Special Bulletin

SP16-316D

Rev D: This revision replaces all previous releases
October 20th, 2016 Added gusset positioning jig

FUEL TANK FRAME FRONT SUPPORT WELD

Figure 5

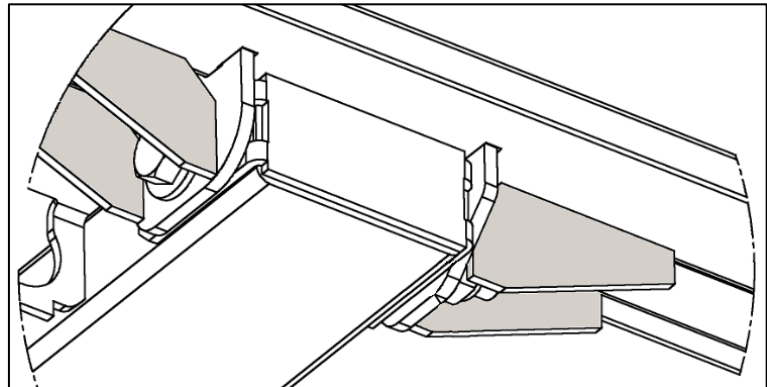
8. Four gussets #240036 will be added on the existing ears, on both sides for a total of 8 gussets. (Fig. 4)

Figure 6

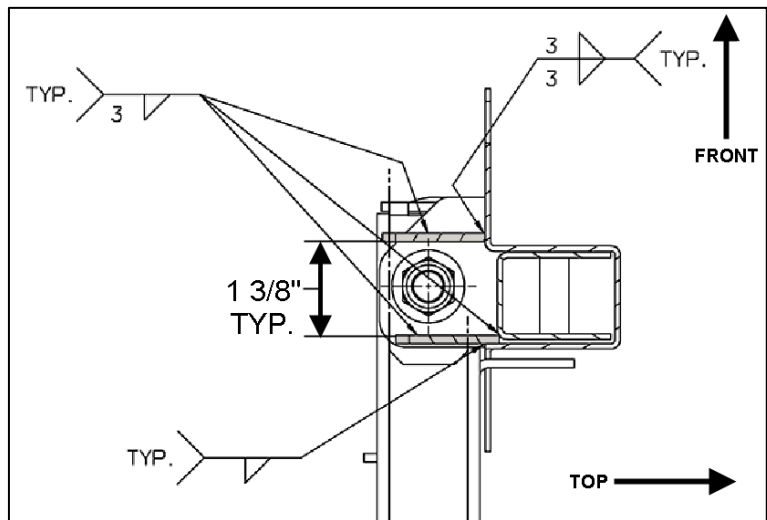
10. Welding Fillet dimension is 3mm (1/8") everywhere. (Fig. 6&7)

Figure 8

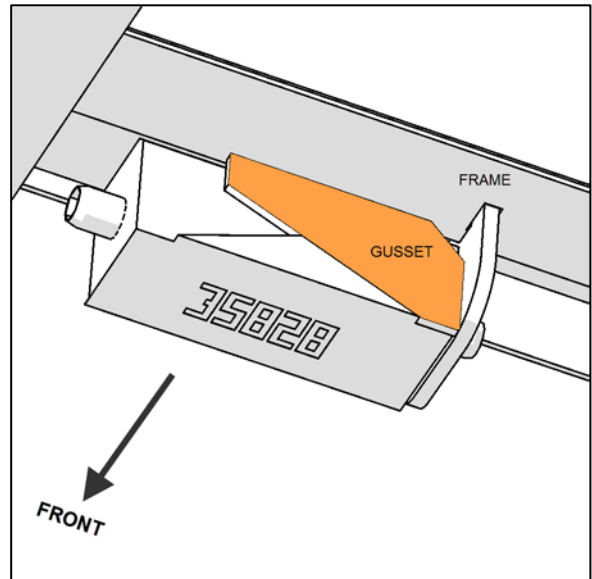
11. Prepare all welding surfaces by grinding.
12. Place Jig #35828 in road side bolt hole.
13. Place gusset #240036 in the rear roadside position of jig. (Fig. 8)

Figure 9

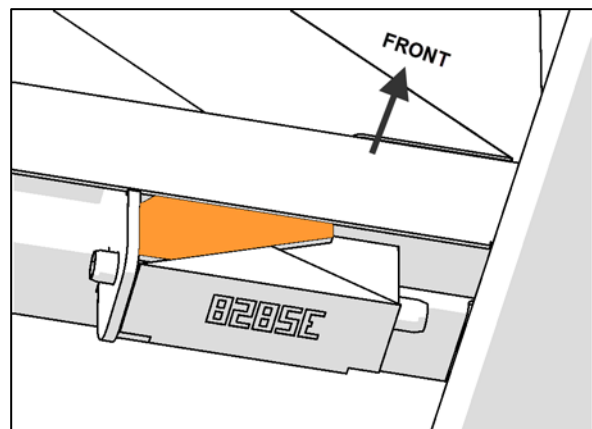
14. Place another gusset #240036 in the front roadside position of the jig. (Fig. 9)

Figure 10

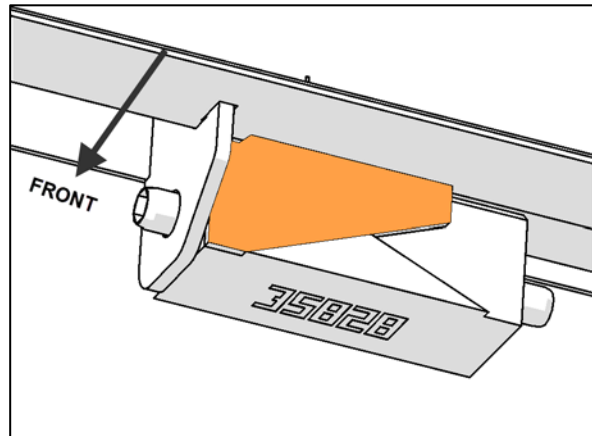
18. Place Jig #35828 in curb side bolt hole.
19. Place gusset #240036 in the rear curbside position of jig. (Fig. 10)

Figure 11

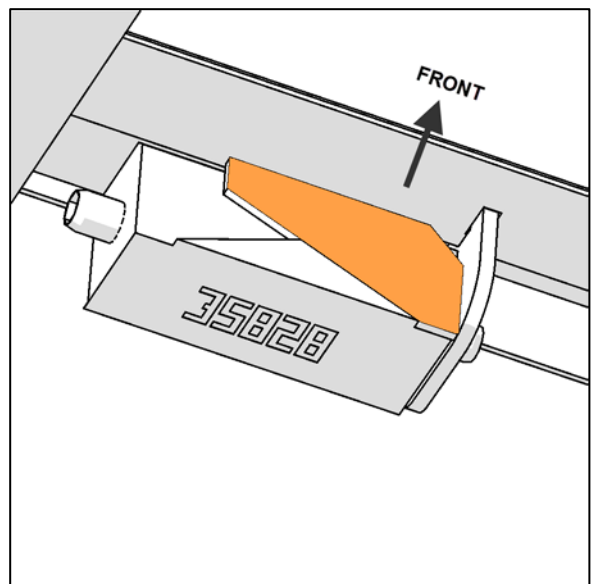
20. Place another gusset in the front curbside position of the jig. (Fig. 11)

Figure 13

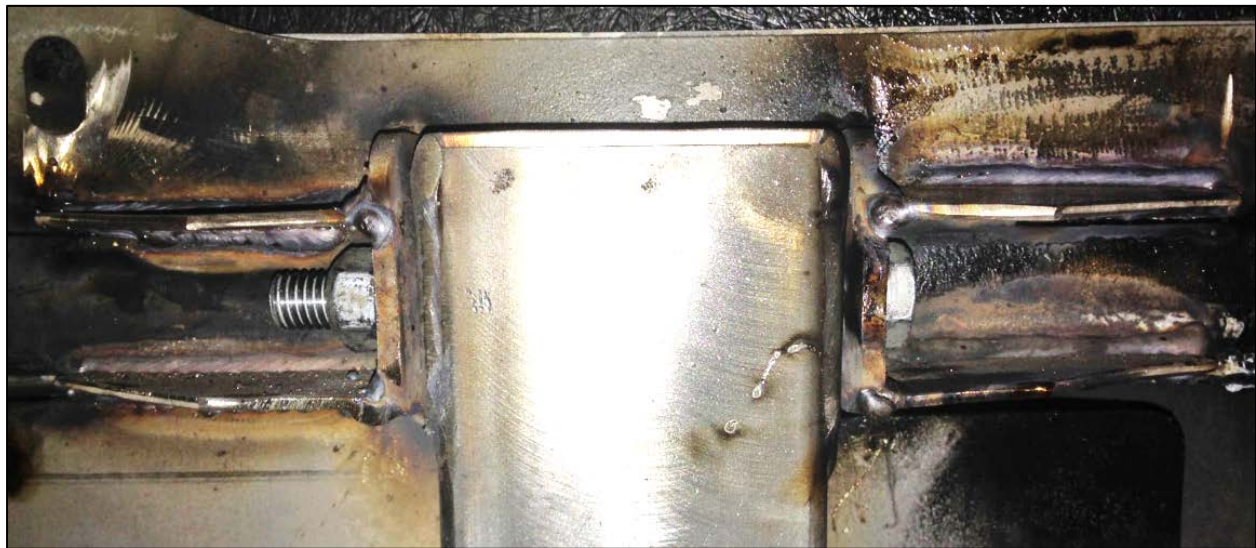
26. Re-install Tank frame mounting hardware

Tighten to **50-60 lb-ft** (67-81 Nm)
